**SAN ANTONIO WATER SYSTEM  
VERANO PHASE II SANITARY SEWER  
SAWS PROJECT # 10-1528 & 10-1529  
ADDENDUM NO. 1**

**January 5, 2012**

The purpose of this addendum is to issue revisions and clarifications for the Verano Phase II – Sanitary Sewer (SAWS Job No. 10-1528 & 10-1529).

JOB NO. 7555-00  
 DATE JULY 2011  
 DESIGNER RLS  
 CHECKED RM DRAWN JA  
 SHEET C4.2

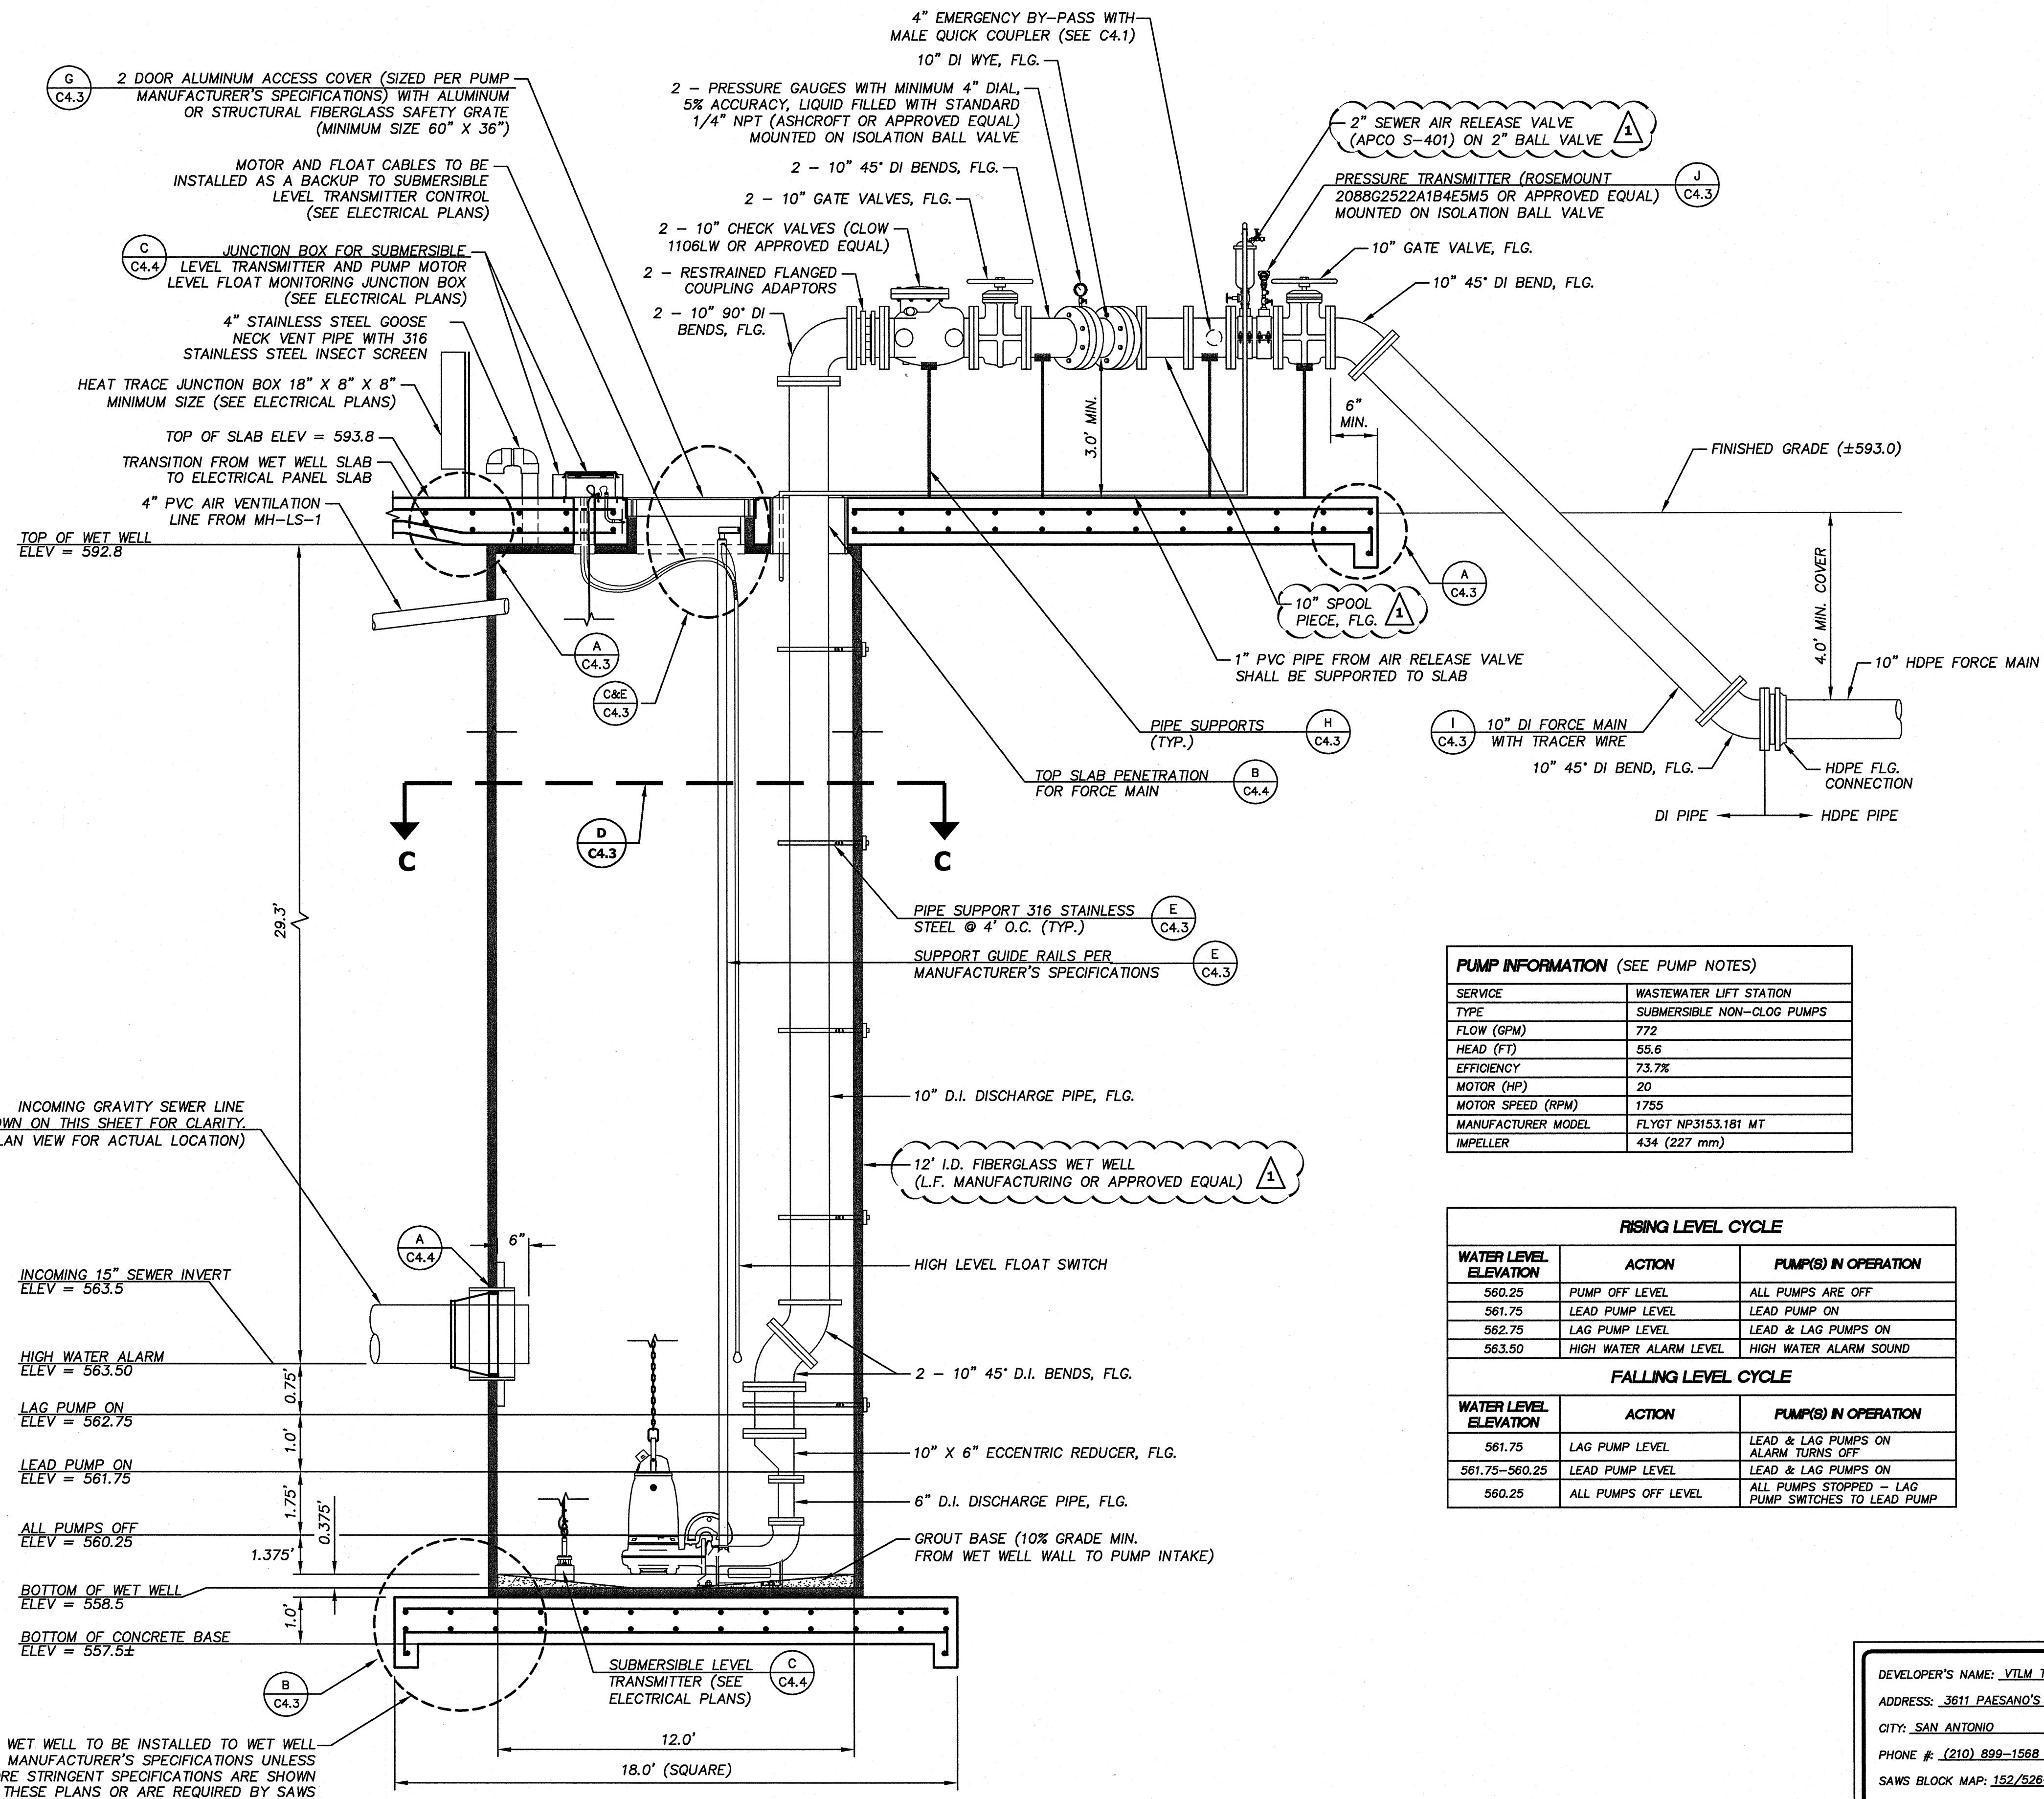
- A. SAWS Job No. 10-1529 – Delete sheet C4.2 and replace with the attached sheet C4.2 to correct water well diameter call out.
- B. SAWS Job No. 10-1529 – Delete Stormwater Pollution Prevention Plan, Exhibit 2, Sheet 1 of 2. Instead, reference SAWS Job No. 10-1528, Stormwater Pollution Prevention Plan, Exhibit 2, Sheet 1 of 1.

REVISIONS:  
 ADDENDUM NO. 1 - 07/05/12  
 REVISE DIAMETER CALL OUTS
